Jitter corner in 100GBASE-ZR

Problem statement

- Draft spec 100GBASE-ZR does not have the usual clock recovery unit in measurement or sinusoidal jitter component in stressed receiver sensitivity definition
 - D3.0 comment 85 and D3.1 comments 69 and 79, comments to D3.2
- So, what does it have?

For EVM, a signal is measured in 1000-UI blocks

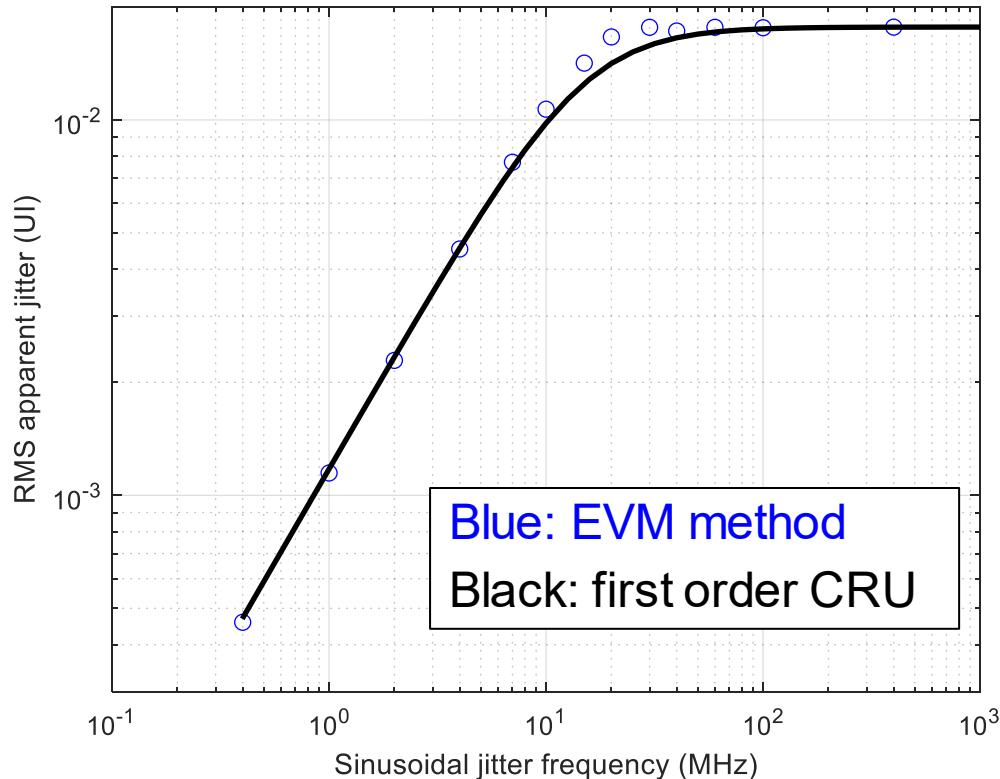
- In each block, the average phase of the data (blue bars) is removed, so the apparent jitter is the red line
- Dashed lines show +/- 1 standard deviation

Apparent SJ after EVM sampling

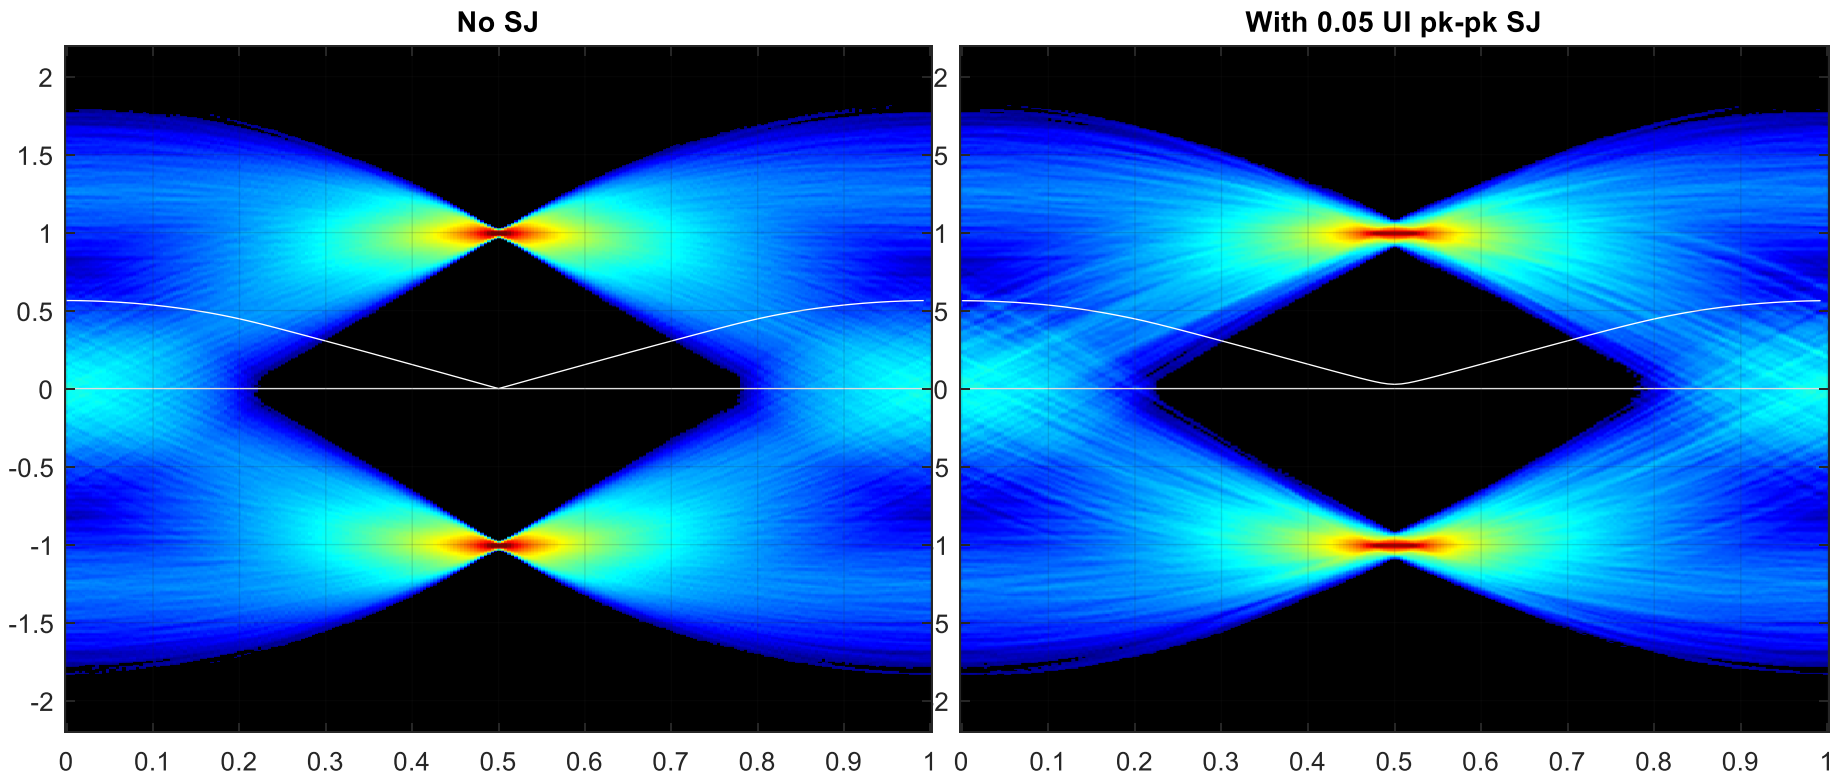
- Effective jitter corner of the default EVM method is 15.1 MHz
 - based on the LF roll-off, which is first order (20 dB/decade). The -3 dB point is 12.8 GHz
- Either way, it's far too high for a DSP receiver, and transmitters can do better
